CITY OF WEST LAKE HILLS, TEXAS
NOTICE OF ZONING & PLANNING COMMISSION (ZAPCO) REGULAR MEETING
Wednesday, July 16, 2025 at 6:30 PM

- a. Approval of the June 18, 2025 Zoning and Planning Commission Minutes.
 - b. Report of previous ZAPCO cases acted on by the BOA/City Council.
4. Public Hearing 1801 Basin Ledge: Discuss and make recommendations on a proposed variance to allow for the removal of one tree 14 inches and greater (Tree 70, 14-inch cedar) (Section 22.03.304 of the West Lake Hills Code).

6. **Public Hearing 105 Wood Trail:** Discuss and make recommendations on proposed variances to the Texas Administrative Code Chapter 30, Chapter 285 adopted in Sections 18.03.064 and 18.03.065 and 22.03.281 of the West Lake Hills Code to allow:
 1. The placement of a structure within 5 feet of a septic facility (TAC 285.91(10); and
 2. The placement of a structure above a septic facility (TAC 285.34(e)(2) and TAC 285.39(c)).

8. **Public Hearing 105 Wood Trail:** Discuss and make recommendations on a proposed variance to Section 22.03.278 and 22.03.281 to allow:
 1. The removal and replacement of impervious cover up to the existing non-conforming amount of 28.5% where 25% is the maximum.

Request

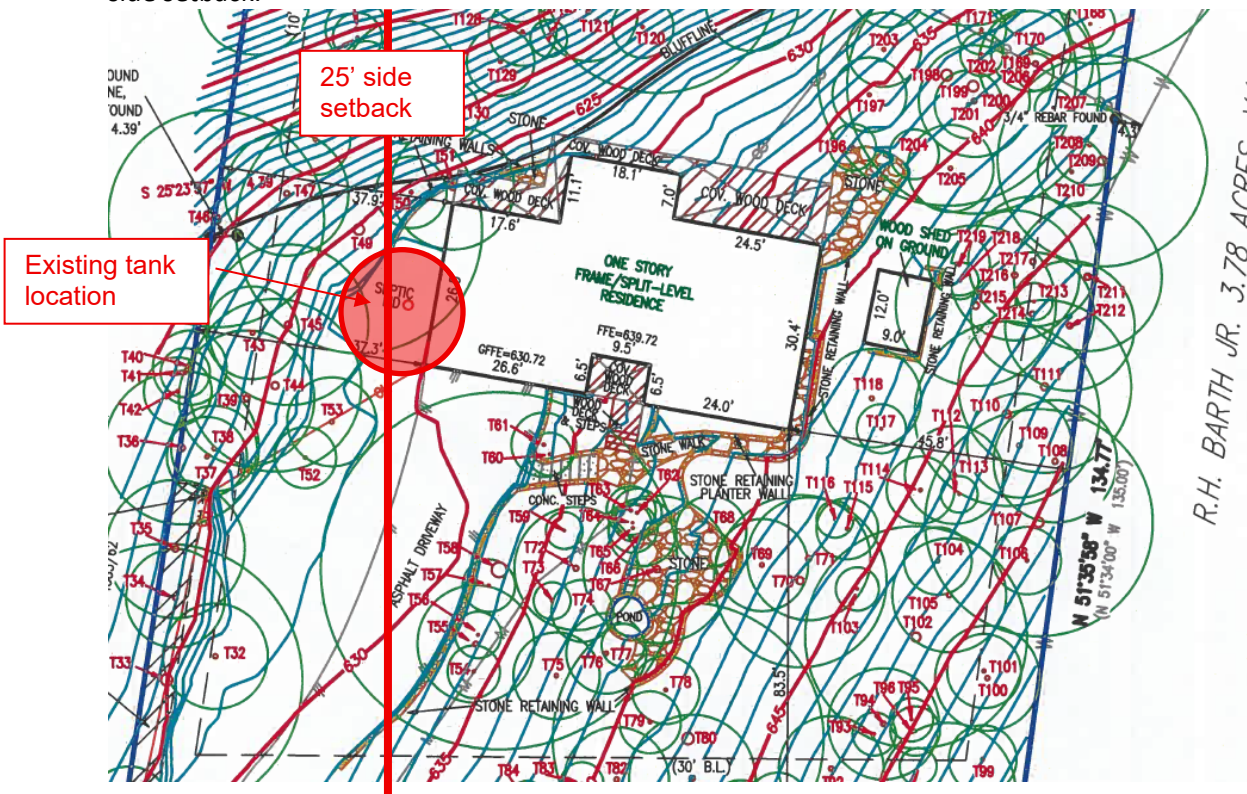
The applicant is requesting a variance to place a new septic tank 15 feet into the 25-foot side setback. The existing septic tank is on the same side of the lot approximately 25 feet from the side property line and out of the side setback.

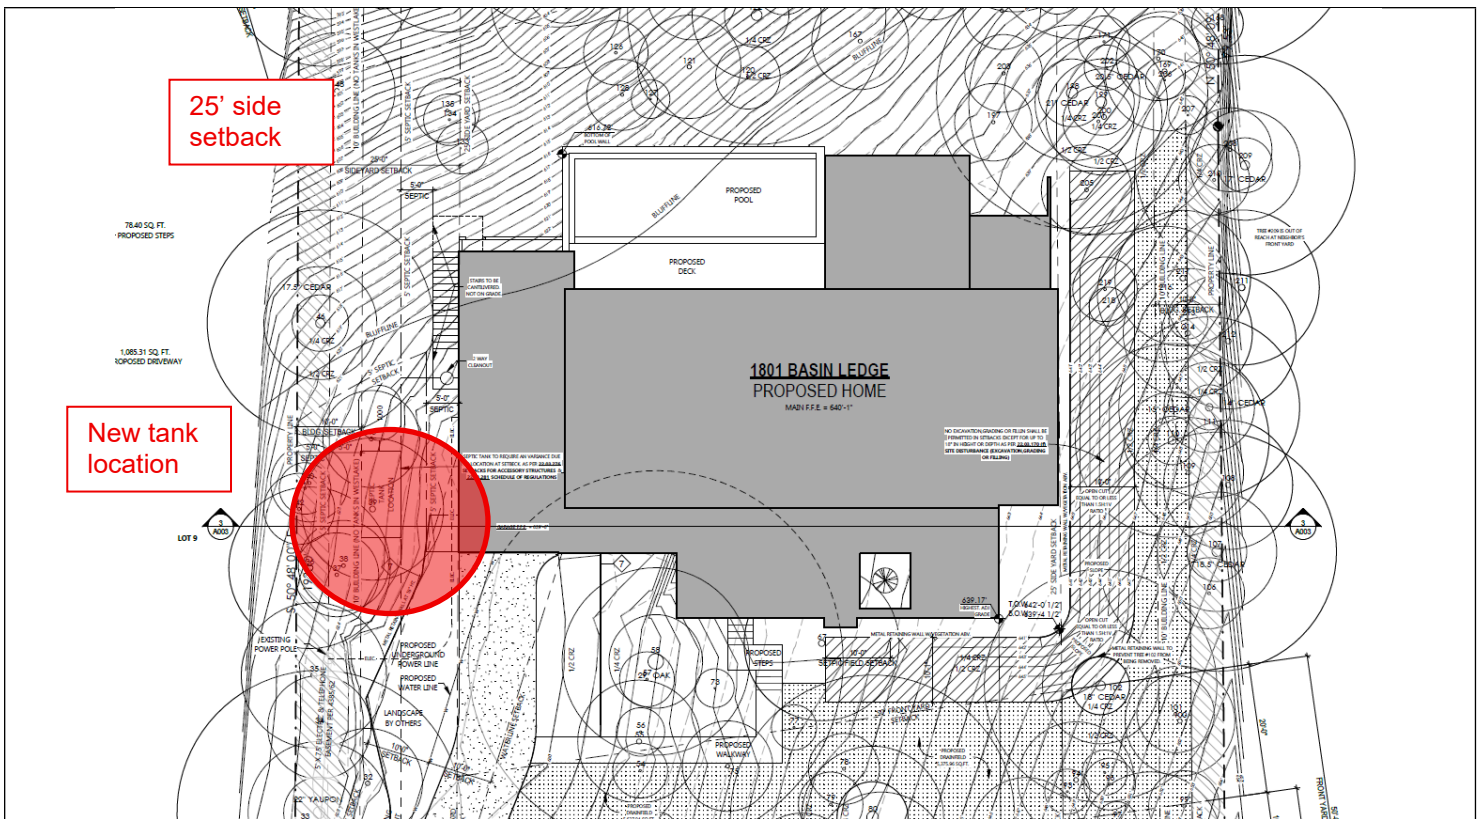
The proposed footprint of the new structure goes up to the side setback lines on both sides.

Request

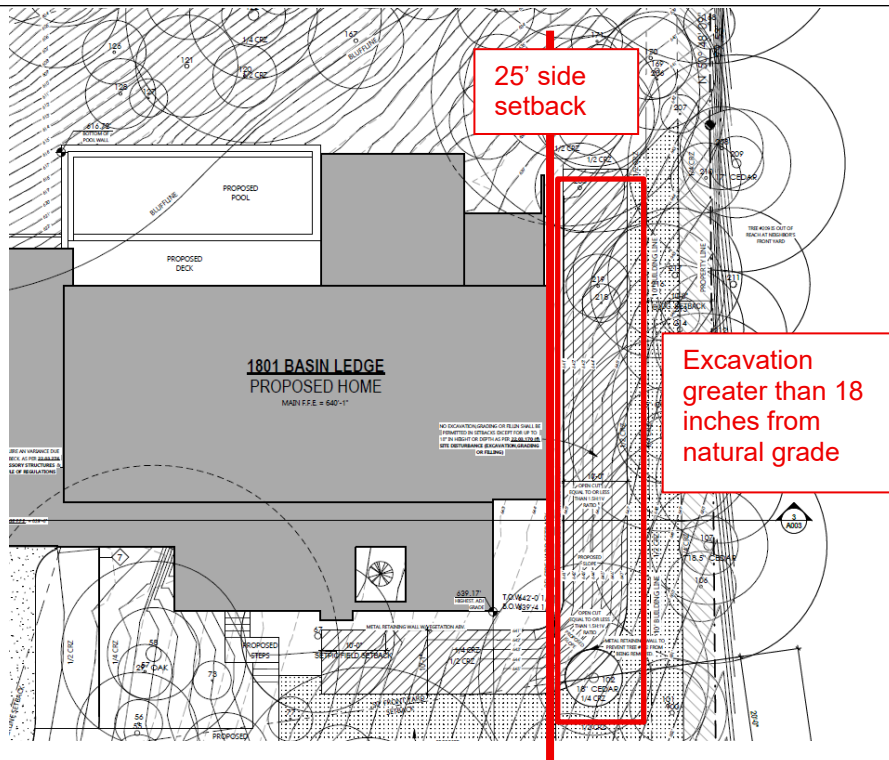
- The applicant's letter does not explicitly call out the grading/excavating more than 18 inches in the setback as a requested variance, but it is listed in their variance justification/findings. The city engineer reviewed the information but is not able to provide a recommendation as it was not listed. Additionally, given the information provided, staff believes that the grading for the house within the buildable area will also exceed limits but there is not enough information provided for evaluation (Attachment 4).
